TITLE: JACK 6PIN		HOMETOM www.hometom.com.tw HORNG TONG ENTERPRISE CO.,LTD.	
TOLERANCE	APPR OVAL:	UNIT:	PART NO:
LINEAR: X ± 0.30 .X ± 0.25 .XX ± 0.20	ANGLE: X° ± 2° .X° ± 1° .XX° ± 0.5°	mm	JK06006BQ7***
CUSTOMER DRAWING	REV: B	CHECK:	SIZE: A4
		DRAWN:	DWG NO: CJK159-00
		SCALE: FIT	PRJ.:
			SHEET: 1 / 2

工程变更申请单

产品名称: JACK 6PIN 客户料号 6-20-B28L0-006 宏通料号: JK06006BQ7648
 变更原因: 文书修正 设计变更 客户要求 品质改善 制程改善 降低成本 其它
 变更前: 变更后: 新增 PLUG 图

工程变更通知单

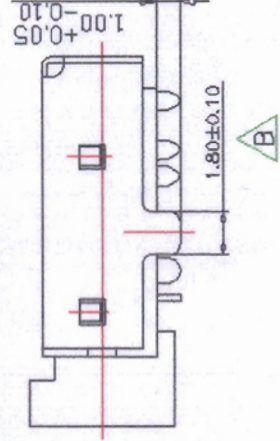
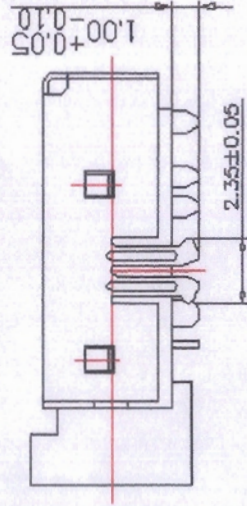
变更说明: 品质改善, 原始鱼叉铜壳厚度较薄容易出现歪PIN现象, 厂内无法完全克服, 同时增加客户批退率, 提投变鱼叉设计, 按照 信音 同款0干涉标准设置, 此设计有利于减少SMT 手插件人员的配置。

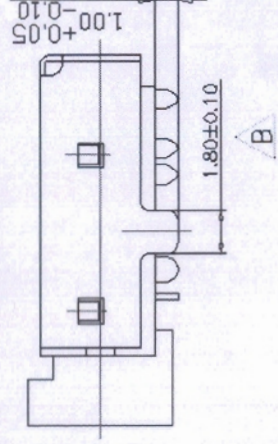
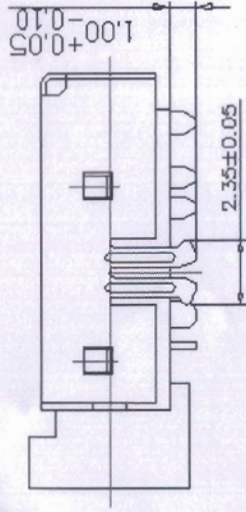
变更说明:
 应客户要求,外壳鱼叉变更规格,要求与主机板"0"干涉.另外图面新增 PLUG 示意图.

产品名称: JACK 6PIN 宏通料号: JK06006BQ7648
 变更原因: 文书修正 设计变更 客户要求 品质改善 制程改善 降低成本 其它
 变更前: 变更后: 新增 PLUG 图

制程管制方式:
 旧品消耗完切换新品,外箱做区分,新品外箱标识"新品"标签.
